**Champlain Hudson Power Express ("CHPE")
Environmental Management & Construction Plan
Notice of Major Change**

Project: Champlain Hudson Power Express

Segment: 9

Notice Number: 123

PERMIT DRAWING NO. **N/A**
 DRAWING NO. **C-408**

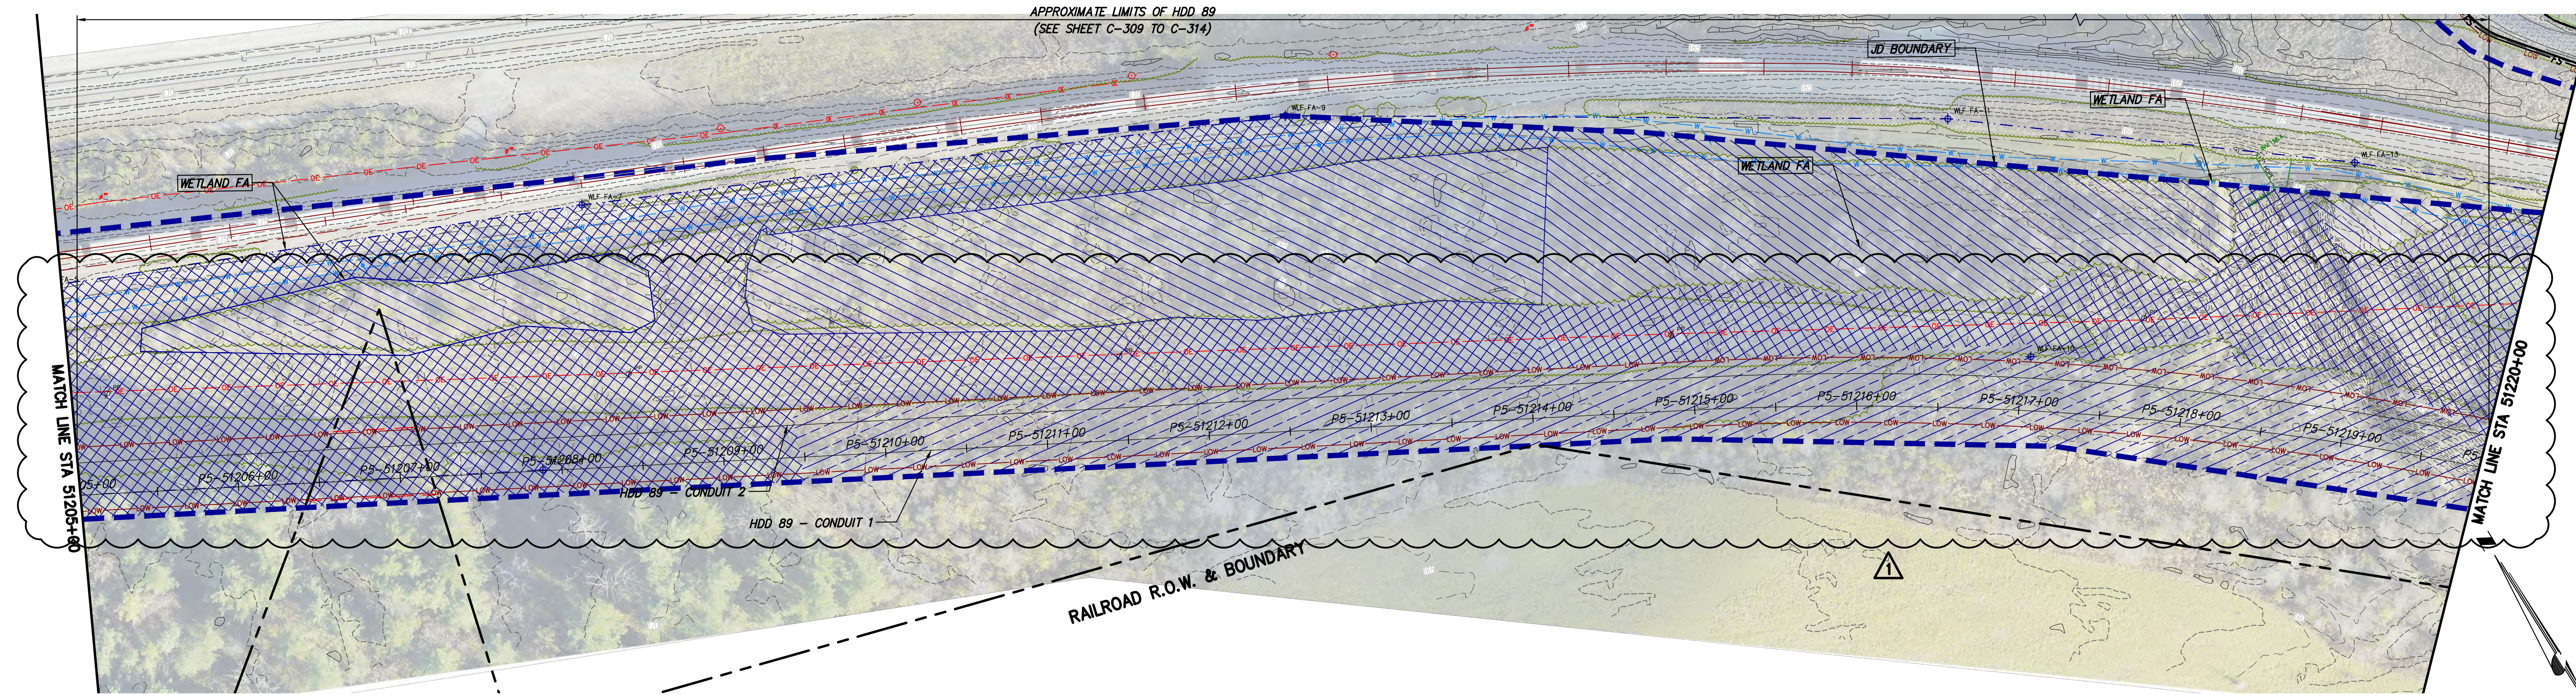
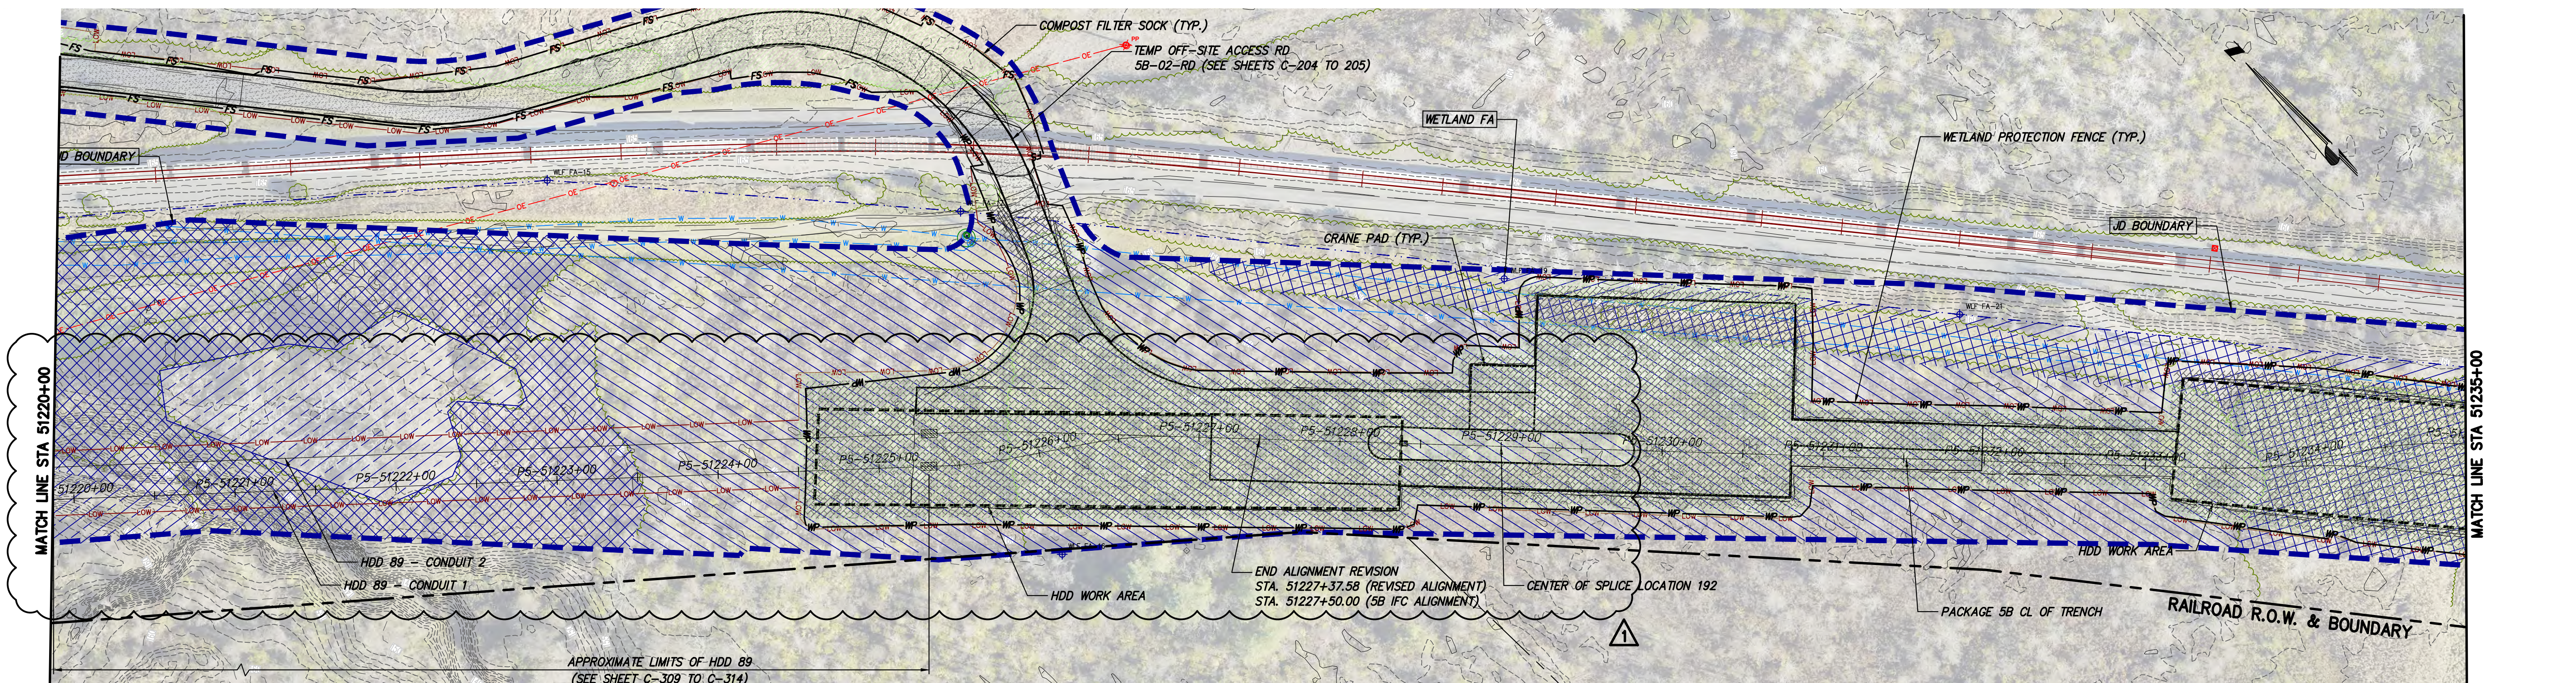
Sheet No.	Rev No.	Revision Description	Summary of Plan Changes
C-114	1	NDC-0005_ALIGNMENT REVISIONS PER NAT. GRID COMMENT	Alignment of HDD adjusted to avoid crossing underneath National Grid overhead electric sub-transmission line from STA 51200+00 to STA 51220+00. Extended HDD 89 workspace in front of pits and adjusted LOW and permanent easement accordingly. Corrected wire pull 191 Direction of cable pull to the preferred reverse direction.
C-115	1	NDC-0005_ALIGNMENT REVISIONS PER NAT. GRID COMMENT	Alignment of HDD adjusted to avoid crossing underneath National Grid overhead electric sub-transmission line from STA 51200+00 to STA 51220+00. Extended HDD 89 workspace in front of pits and adjusted LOW accordingly.
C-116	1	NDC-0005_ALIGNMENT REVISIONS PER NAT. GRID COMMENT	Alignment of HDD adjusted to avoid crossing underneath National Grid overhead electric sub-transmission line from STA 51200+00 to STA 51220+00. Extended HDD 89 workspace in front of pits and adjusted LOW accordingly. Corrected wire pull 193 Direction of cable pull to the preferred reverse direction.

No.	DATE	SUBMITTAL / REVISION DESCRIPTION	DB	APP
1	03/26/2024	NDC-0005: ALIGNMENT REVISIONS PER NAT. GRID COMMENT	BL	BD
0	06/09/2023	ISSUED FOR CONSTRUCTION SUBMISSION	MK/TH	NH

CHPE Segment 9 (Package 5B) EM&CP Appendix E Added Sheet

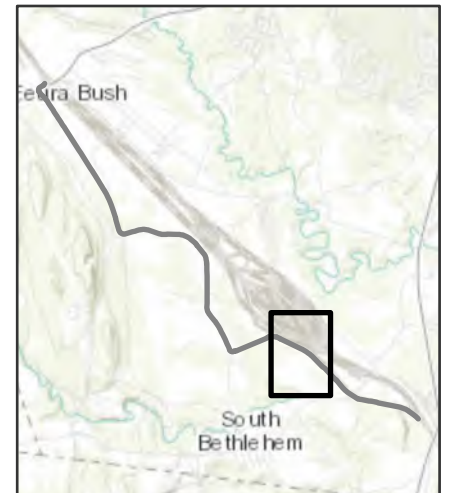
Excursion S9-3 is located within the Town of Bethlehem beginning approximately 0.8 miles north of Bridge Street (Rt. 396) crossing under CSX tracks (approximately STA 51204+00 to 51215+00). See Sheet C-114 and C-115 attached..

The anticipated ADZ exceedance constitutes a major change as it is 22 feet perpendicular to the ADZ at its furthest point; environmental impacts will be reduced as noted above, and the overall character of the Facility will not be changed. A detailed impact review and summary of environmental considerations are provided below for the 1,100' of HDD.
